Safety Evaluation Report

Related to the Operation of
Watts Bar Nuclear Plant, Unit 2

Docket Number 50-391

Tennessee Valley Authority

Figure 15.1-1 Illustration of overtemperature and overpower delta-T protection

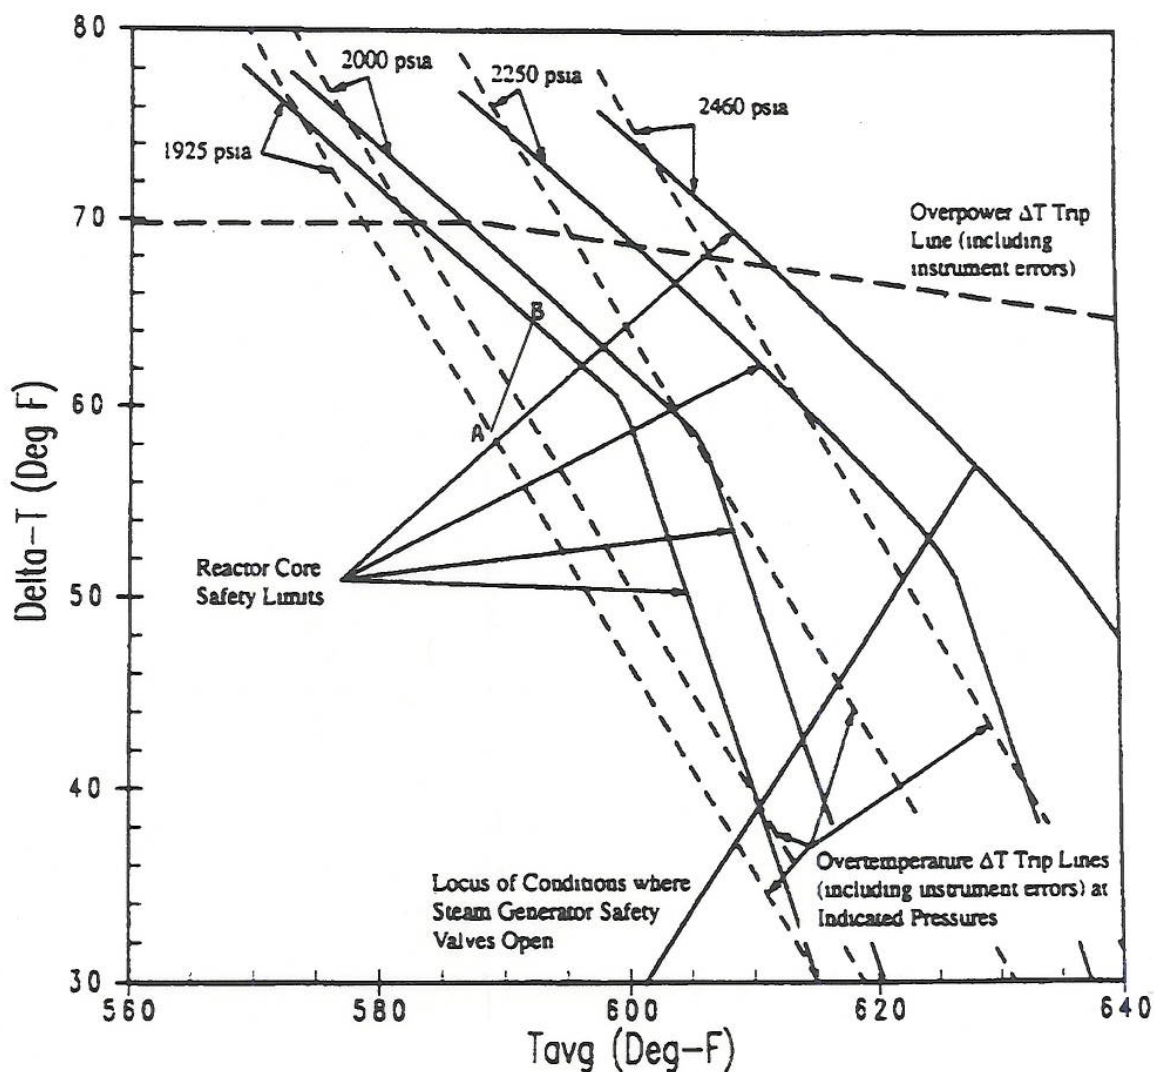
TVA compared the RCS temperature, pressurizer pressure, and core power level (indicated by ΔT) for each of the various initial conditions, or statepoints, to the RCS temperature, pressurizer pressure, and core power level values that would produce the DNBR SAL. Figure 15.1-1, "Illustration of Overtemperature and Overpower Delta-T Protection," in the FSAR for WBN Unit 2 and reproduced below depicts the locus of points, on a plot of ΔT versus average T (degrees Celsius (C) (Fahrenheit (F))), at which the DNBR is at the DNBR SAL. This figure also depicts plots of the calculated overpower and overtemperature ΔT reactor trip setpoints that are intended to trip the reactor before conditions can reach those corresponding to the DNBR SAL.

Using FSAR Figure 15.1-1, the NRC staff located the nominal operating condition ($T_{avg}=588.2$ degrees F and $\Delta T=58.4$ degrees F) and designated it as point A. The nominal operating condition lies well below and to the left of the DNBR SAL and overtemperature ΔT lines that correspond to operation at nominal pressure (2,250 pounds-force per square inch (psia)). Point A represents the plant operating conditions that would exist before the occurrence of a 10-percent step-load increase. A second point (point B), representing operation at 110-percent power (i.e., the endpoint of a 10-percent step-load increase) was marked on the figure at $T_{avg}=591.1$ degrees F and $\Delta T=64.2$ degrees F. The line connecting the two points maps the path, from point A to point B, of an excessive load increase incident relative to the DNBR SAL. It extends upward and to the right, toward the DNBR SAL and overtemperature ΔT lines that correspond to operation at nominal pressure.

Therefore, the NRC staff's exercise, employing FSAR Figure 15.1-1, verifies TVA's conclusion that the DNBR SAL is not violated in the event of an excessive load increase incident. The nature of the event (a cooldown and possible depressurization) indicates that RCPB integrity is not challenged. Although a reactor trip might be required, it could not be prevented, delayed, or otherwise impeded by a single failure.
